## SERVICE INFORMATION BULLETIN

**APPLICABILITY:** 2015-17MY WRX and WRX STI  
 2014-2017MY Forester  
 2012-2016MY Impreza  
 2013-2017MY Crosstrek

**NUMBER:** 09-64-16  
**DATE:** 12/16/16

**SUBJECT:** Sub-Level Sensor Flange Nut Cap Shape Change

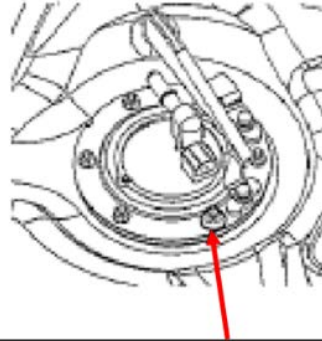
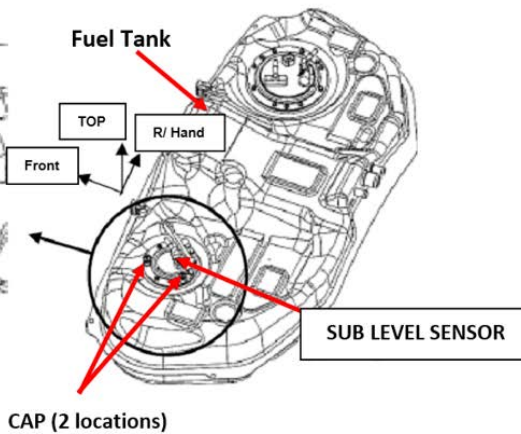
This Service Information bulletin announces a change to the shape of the rubber cap used on the flange nuts securing the sub-level sending unit to the fuel tank. In addition, two of the caps are now used in production instead of only one. This change was made to enhance productivity during vehicle assembly.

The illustrations below show the shape change, location and quantity of the caps used.

"OLD" Style Cap Used in Only 1 Location

Close-Up View  
Location of  
Additional CAP

CAP (2 locations)

- On vehicles produced after July, 2016, a second cap was added in the location shown above.
- Production of the old style cap has been discontinued. Use the new style cap whenever replacement is required.
- Both the new and old style caps can be reused. They are NOT one-time use items.

The part number for the new style cap is **42031SG000**.

42031SG000 "NEW" STYLE CAP
